**ENA EREC P28 Issue 2 2018
Key Technical Modifications
Grid Code and SQSS Mods**

- Background to revision of ER P28 Issue 1
- Key technical modifications in EREC P28 Issue 2
- Other modifications
- Draft proposed changes to the Distribution Code (DCODE)
- Public consultation.

Proposed RVC Limits (P28 Issue 2)

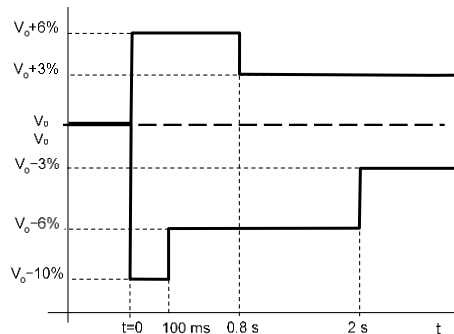
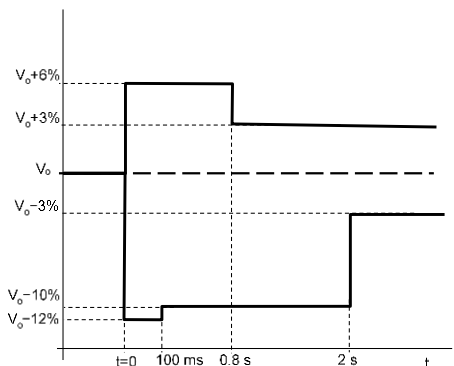
- Basis was Grid Code Modification GC0076
- No change to general step voltage change ($\Delta V_{\text{steadystate}}$) limit of $\pm 3\%$
- 3 categories of RVC events (number of occurrences)
 - Frequent (single or repetitive RVC)
 - Infrequent (Max of 4 events per calendar month)
 - Very Infrequent (Max of 1 event in 3 calendar months)
- No more than 1 event per day, with up to 4 RVCs, separated by at least 10 minutes, with all switching completed within a 2 h window.

P28 Issue 1 permits design for:

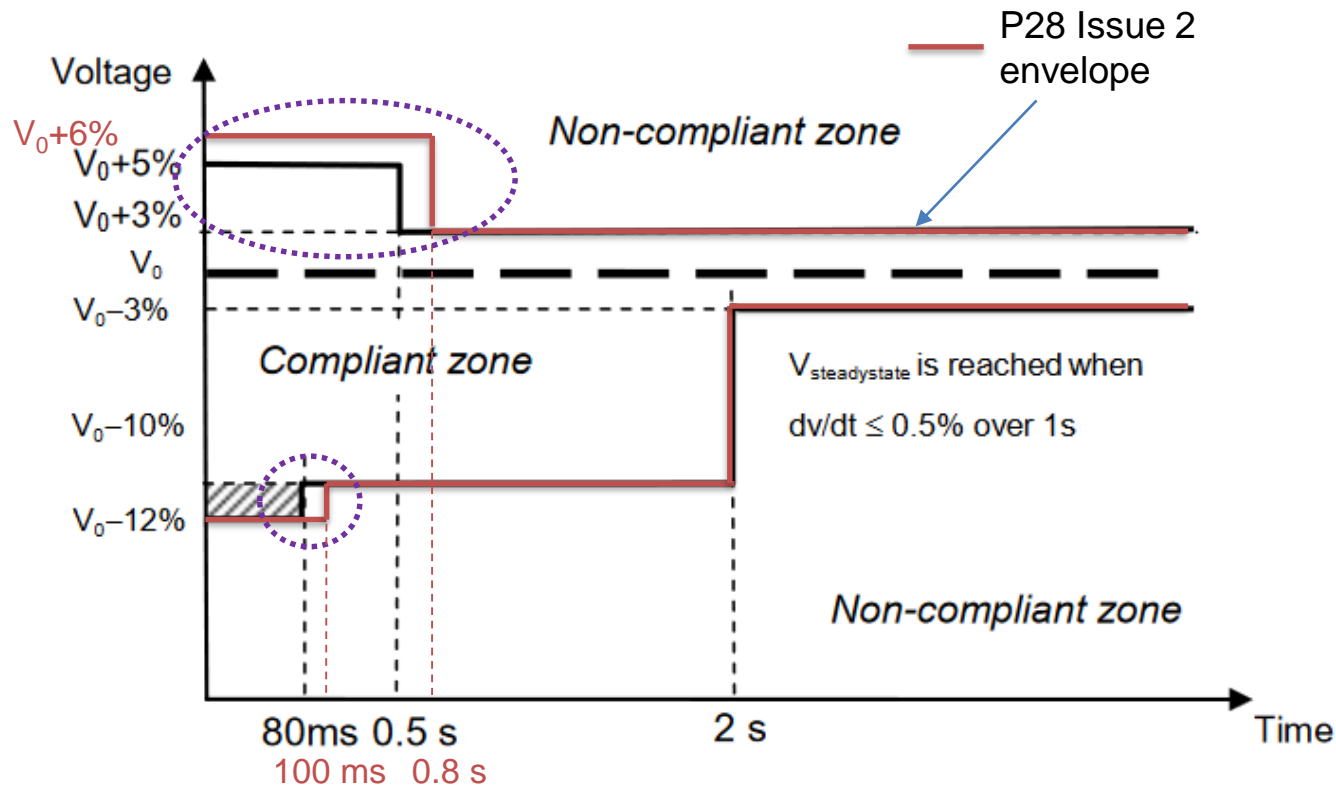
- step voltage changes of $\pm 3\%$ for infrequent planned events
- voltage depression $> 3\%$ but $\leq 6\%$ permitted for very infrequent motor starting

DCODE DPC4.2.3.3 permits voltage depression of around 10% for transformer energisation (once per year)
